Item Name: Fwd Crosstube - High 407

DART AEROSPACE LTD		Work Order:	131481
Description: Crosstube High Fwd (407)		Part Number:	D407-667-105
Inspection Dwg: D407-667-145 Rev: C		Page 1 of 1

DRAWING NO. D407-667-145	TITLE CROSSTUBE ASS'Y (407 HIGH FWD)	REV. C	DART AEROSPACE LTD ENGINEERING ORDER		D.E.O. NO. D407-667-145-C-1	SHEET NO. SHEET 1 OF 1	SCALE NTS
DRAWN <i>JP</i>	CHECKED <i>ASS</i>	MFG. APPR. <i>AB</i>	APPROVED <i>WD</i>		DE APPR. <i>AB</i>		
DATE 11.07.15	DATE 11.07.22	DATE 11.07.22	DATE 11/07/22		DATE 11.07.21

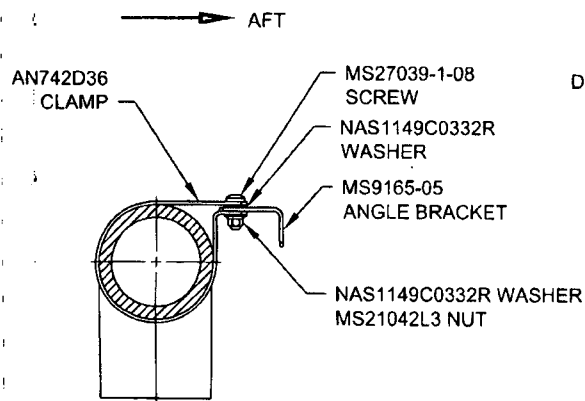
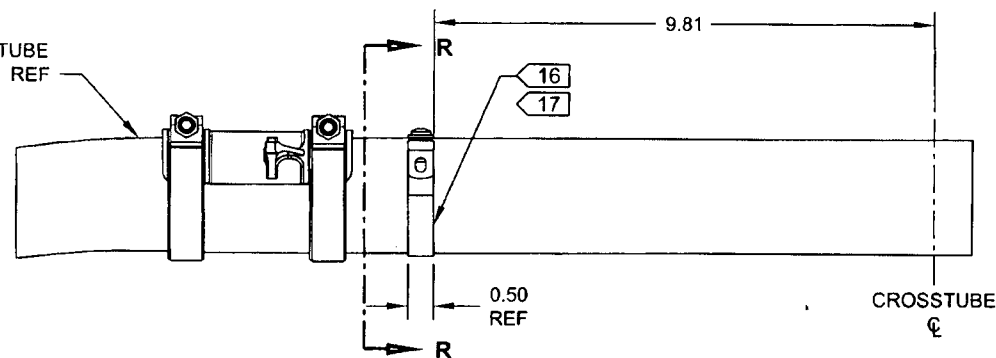
PURPOSE:

ADD ELECTRICAL GROUNDING STRAP

ITEM	QTY -145	PART NUMBER	DESCRIPTION
1	X	D407-667-145	CROSSTUBE ASSEMBLY (407 HIGH FWD)
⚡			
10	2	AN742D36	CLAMP
11	2	MS9165-05	ANGLE BRACKET
12	2	MS21042L3	NUT (OR MS21042-3)
13	2	MS27039-1-08	SCREW
14	4	NAS1149C0332R	WASHER (OR AN960C10L)

- 16) MASK AREA UNDER CLAMP PRIOR TO PAINTING
- 17) SEAL EDGES WHERE AN742D36 CLAMP MEETS WITH THE CROSSTUBE USING SIKAFLEX-241/-291 OR MIL-S-8802 CLASS B2 OR PROSEAL 890 SEALANT
- 18) PERFORM RESISTANCE CHECK TO ENSURE MAX RESISTANCE IS 10 MILLIOHMS
